## Service Bulletin

NO. 321

### Studebaker and Packard Clipper

Fig. 3 1. Governor prive Ball Pocket

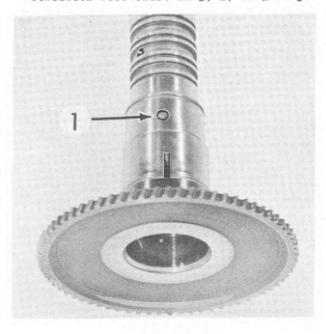
The correct position of the tube within the output shaft can be determined as follows: with the output shaft out of the transmission locate the governor drive ball pocket in the shaft (see Fig. 3). Then, looking at the front of the output shaft assembly, locate the elongation of the oil passage in the center of the distributor tube (see Fig. 4). Using the governor drive ball pocket as a reference point, the elongated portion of the passage should be located 1800 from (or relatively opposite) the governor drive ball pocket.

Fig. 4

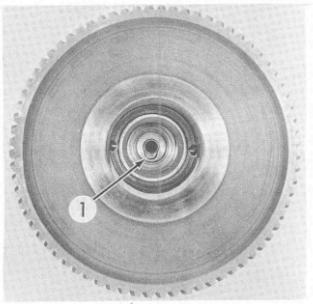
#### 1. Elongation of Oil Passage
